SUBJECT: Forwards add info re departure from nucleate boiling ratio  
 rod bow penalty, in response to NRC 810831 ltr. Also forwards  
 proposed revised Tech Spec pages which reflect new limits  
 based on revised reactor protection sys string errors.

Re: Oconee Nuclear Station  
Docket No. 50-269

## ATTACHMENT 1

Proposed Technical Specification Revision

FIGURE 1  
OCONEE GENERIC  
ROD BOW PENALTY VS. BURNUP

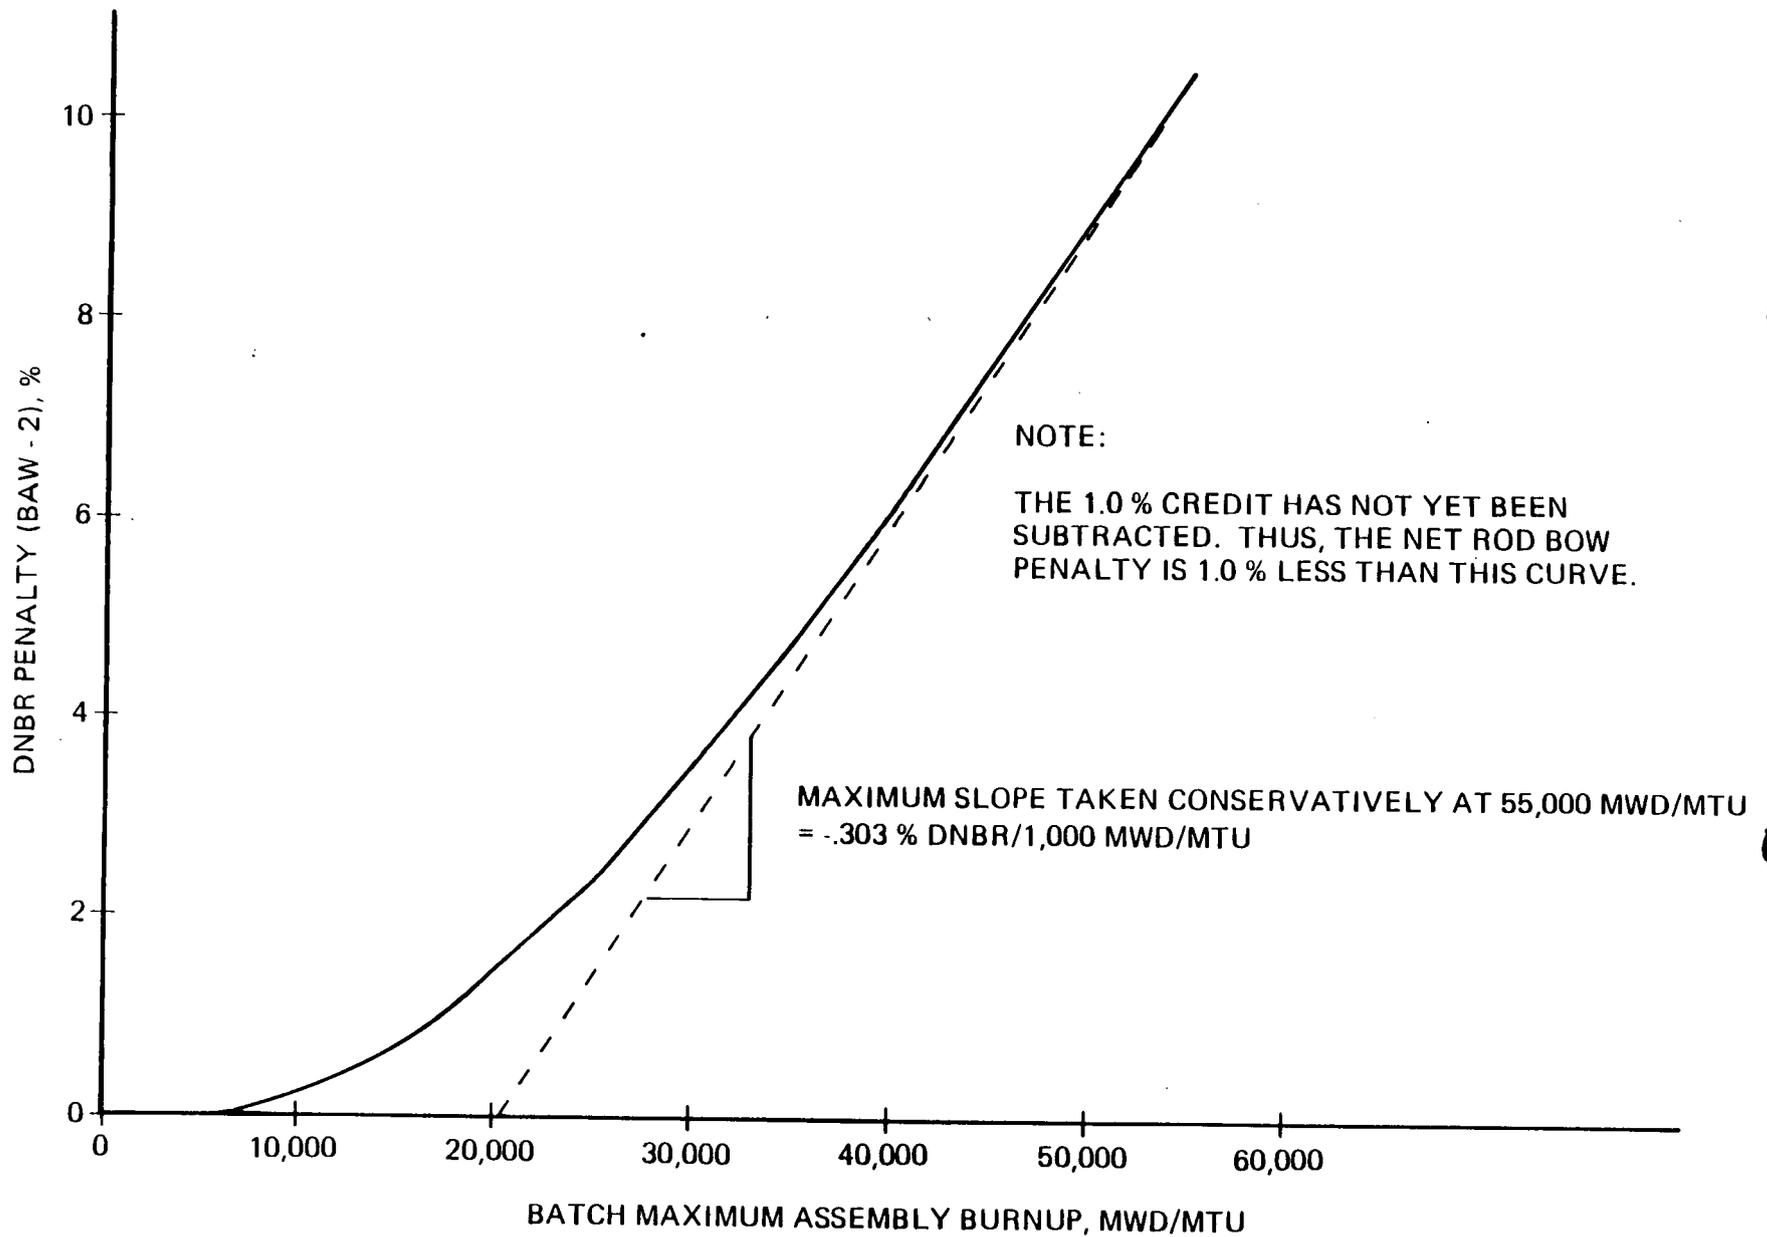
3. Calculate the rod bow penalty at 55,000 MWD/MTU, using the interim rod bow procedure, and extend the historic rod bow penalty versus burnup curve to include the batch 4E assembly of Oconee 1 Cycle 7 (Figure 1).

Table 2 presents the pin peaking reduction required to offset a DNBR change. The maximum percent reduction in pin peak per percent change in hot channel minimum DNBR was observed to be -.61. This DNBR credit for peaking reduction was combined with the maximum rate of change of rod bow penalty with respect to batch maximum fuel assembly burnup change (Figure 1) to obtain a pin peaking reduction trade-off against batch maximum fuel assembly burnup, as follows:

Table 1 confirms that the net rod bow penalty for batch 9 fuel (0.2%) is most limiting. Thus the Reload Report and Technical Specifications are acceptable as written. (A minor error on page 6-1 of the Reload Report is noted however: batch 9 maximum fuel assembly burnup is 17669, not 17649. The 0.2 percent net rod bow penalty does envelope 17669, as seen from Figure 1.)

CORE PROTECTION  
SAFETY LIMITS  
UNIT 1  
OCONEE NUCLEAR STATION  
Figure 2.1-3A

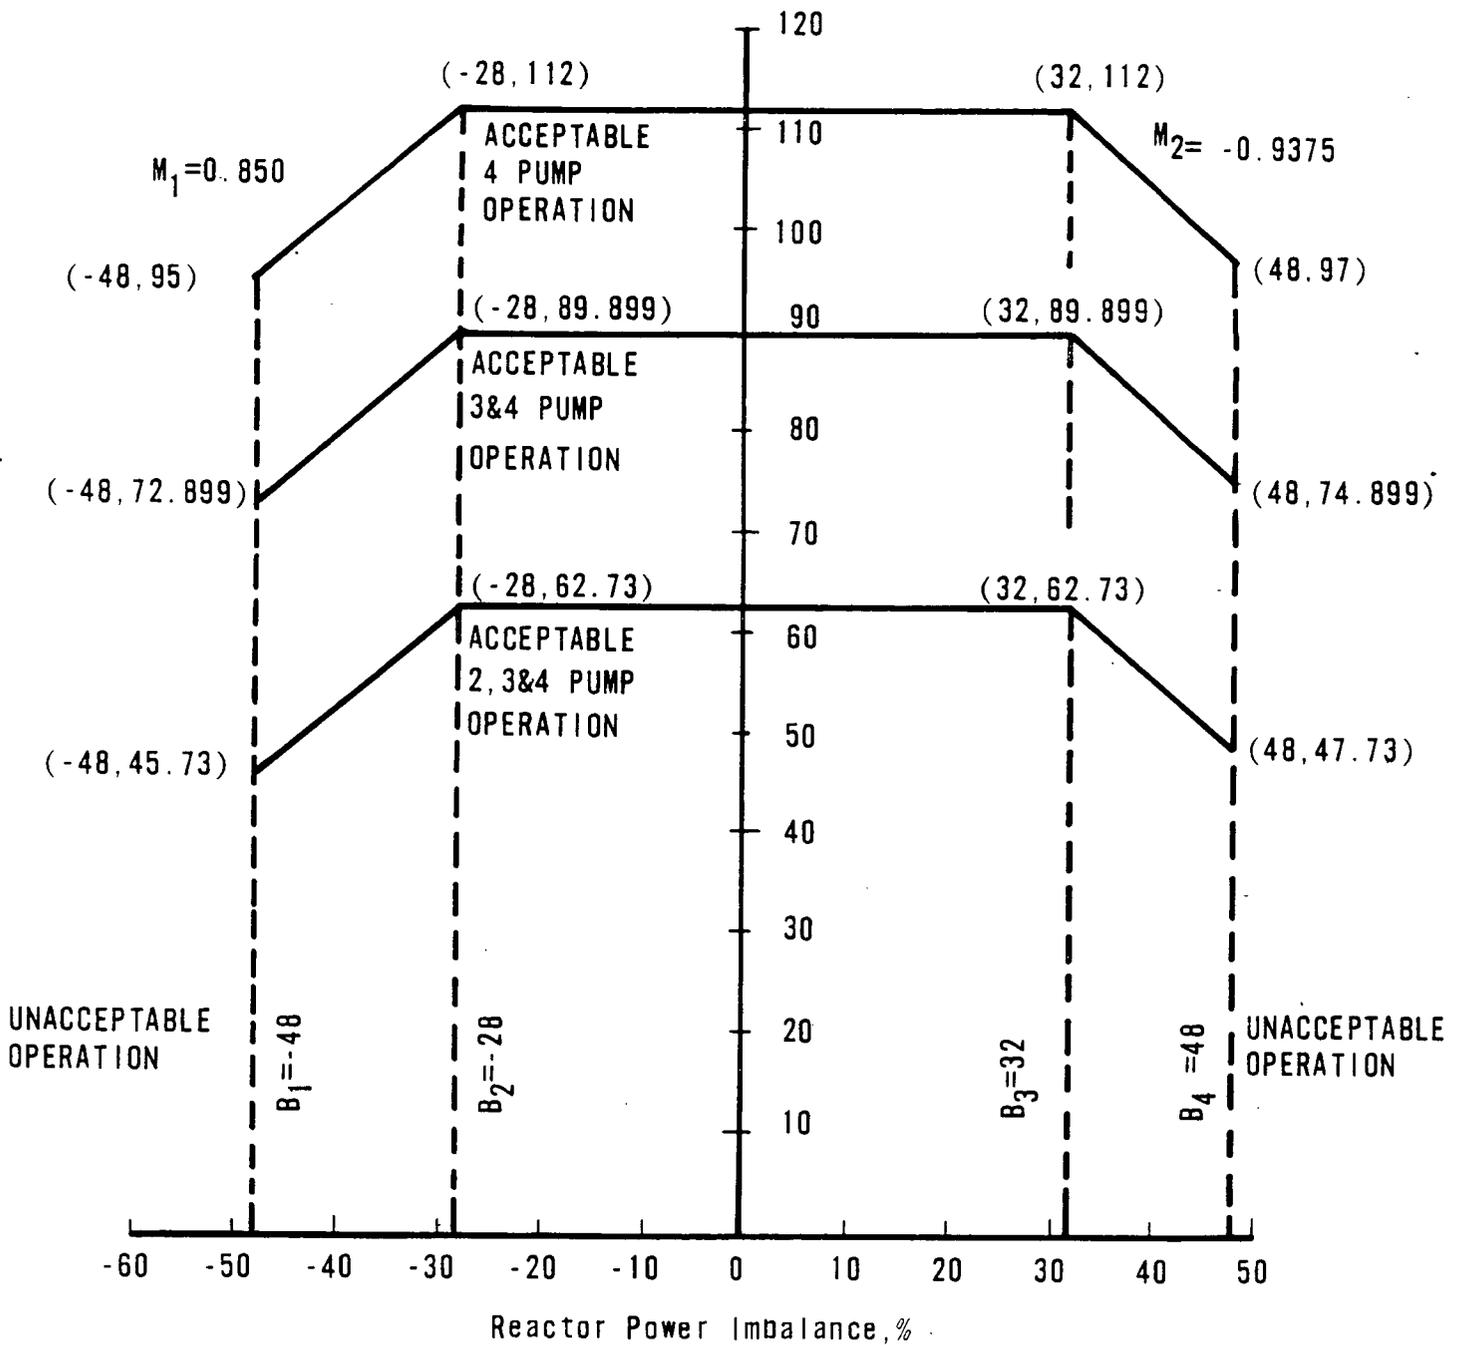
For Figure 2.1-3A, a pressure-temperature point above and to the left of the curve would result in a DNBR greater than 1.30.

CORE PROTECTION  
SAFETY LIMITS  
UNIT 1  
OCONEE NUCLEAR STATION  
Figure 2.1-2A

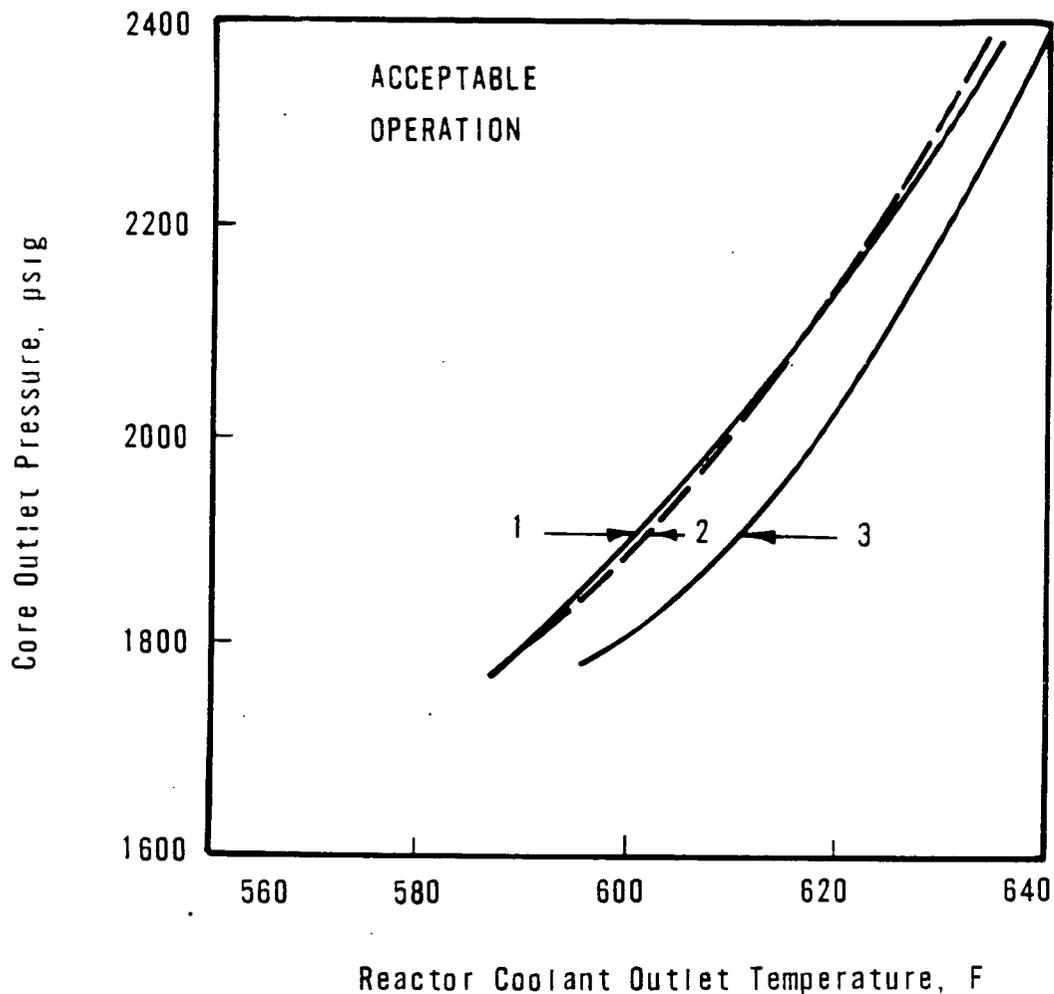
The maximum thermal power for three-pump operation is 89.899 percent due to a power level trip produced by the flux-flow ratio 74.7 percent flow x 1.07 = 79.929 percent power plus the maximum calibration and instrument error. The maximum thermal power for other coolant pump conditions are produced in a similar manner.

PROTECTIVE SYSTEM MAXIMUM ALLOWABLE SETPOINTS  
 UNIT 1  
 OCONEE NUCLEAR STATION  
 Figure 2.3-2A

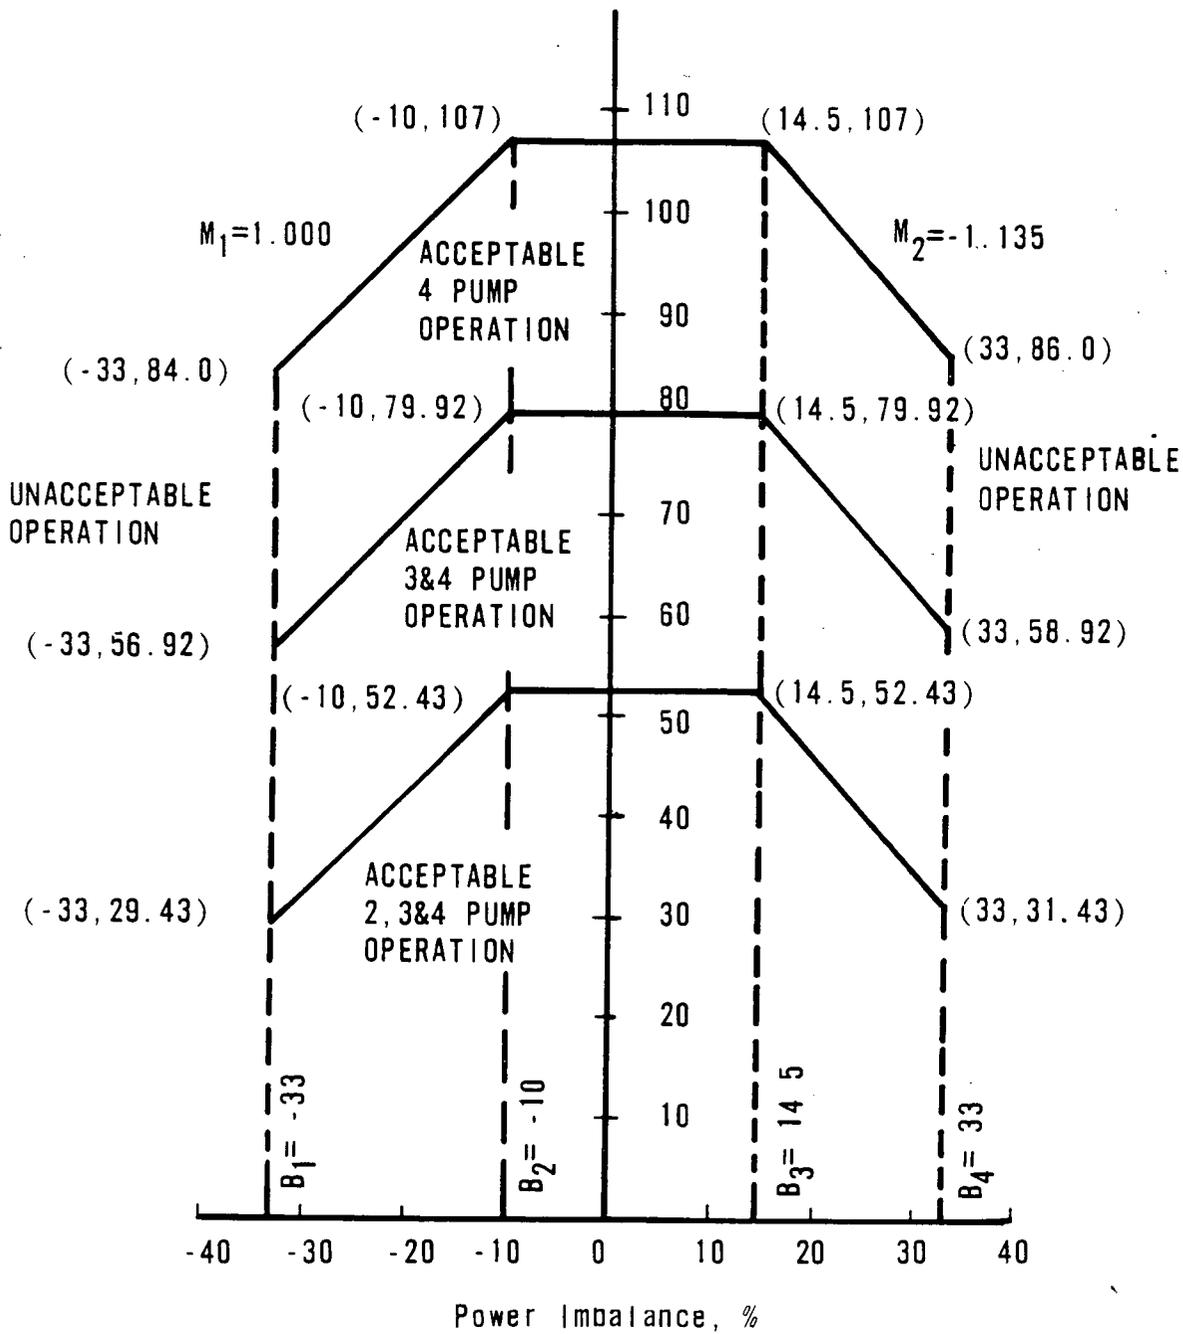
The power-imbalance boundaries are established in order to prevent reactor thermal limits from being exceeded. These thermal limits are either power peaking kw/ft limits or DNBR limits. The reactor power imbalance (power in the top half of core minus power in the bottom half of core) reduces the power level trip produced by the power-to-flow ratio such that the boundaries of Figure 2.3-2A - Unit 1 are produced. The power-to-flow ratio reduces the power

level trip and associated reactor power/reactor power-imbalance boundaries by 1.07% - Unit 1 for 1% flow reduction.
